UNITED STATES DEPARTMENT OF THE INTERIOR BUREAU OF LAND MANAGEMENT

SUNDRY NUTICES AND REPORTS ON WELLS	
Do not use this form for proposals to drill or to re-enter an ETESIAO.CD	۸
abandonad wall the fame according to a SIGNAR POINT I WAR I SIALOW	٥,

6. If Indian, Allottee or Tribe Name abandoned well. Use form 3160-3 (APD) for នយុះស្នេចទៅទៀ 7. If Unit or CA/Agreement, Name and/or No. SUBMIT IN TRIPLICATE - Other instructions on page 2 8. Well Name and No. DRY LAND SWD 1 ☐ Oil Well ☐ Gas Well 🗷 Other: **UNKNOWN OTH** Name of Operator
 COG OPERATING LLC Contact: ABIGAIL ANDERSON API Well No. E-Mail: abbym@bcmandassociates.com 30-015-33458-00-S1 10. Field and Pool or Exploratory Area 3b. Phone No. (include area code) 600 W ILLINOIS AVENUE Ph: 432-580-7161 PERMO PENN MIDLAND, TX 79701 4. Location of Well (Footage, Sec., T., R., M., or Survey Description) 11. County or Parish, State Sec 3 T21S R25E NESE 2852FSL 377FEL EDDY COUNTY, NM

Permanent Abandonment of Federal Wells Conditions of Approval

COG Sp	erating, LLC		
Author:	BCM & Associates, INC		
Well Name	Dry Land SWD	Well No.	#1
Field	SWD; Permo Penn	API#:	30-015-33458
County	Eddy	Pгор #:	
State	New Mexico	Zone:	P-3-21S-25E
Spud Date	7/16/2004	_	2852'FSL 377'FEL
GL	3272'

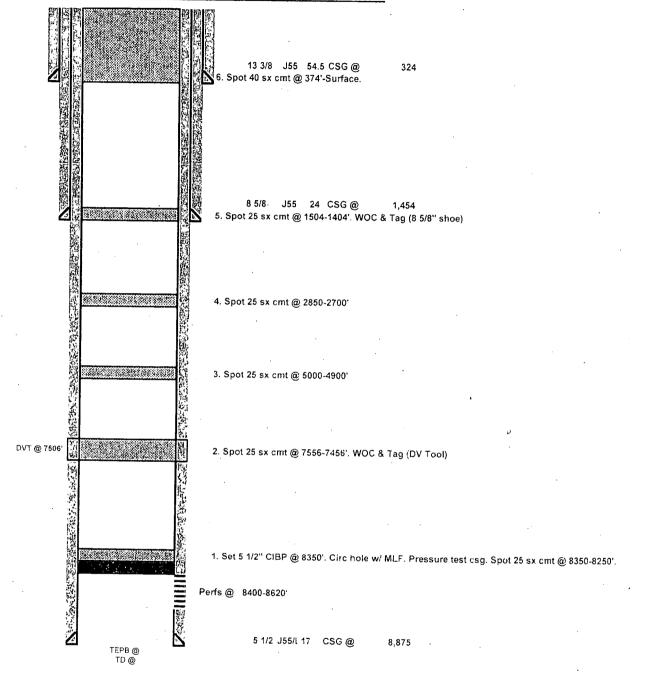
- Set 5 1/2" CIBP @ 8350'. Circulate hole w/ MLF. Pressure test csg. Spot 25 sx cmt @ 8350-8250'.

4. Spot 25 sx cmt @ 2850-2700"

5. Spot 25 sx cmt @ 1504-1404'. WOC & Tag (8 5/8" Shoe)

6. Spot 40 sx cmt @ 374-Surface.

Cut off well head, verify cmt to surface, weld on Dry Hole Marker.

SEE ATTACHED FOR CONDITIONS OF APPROVAL
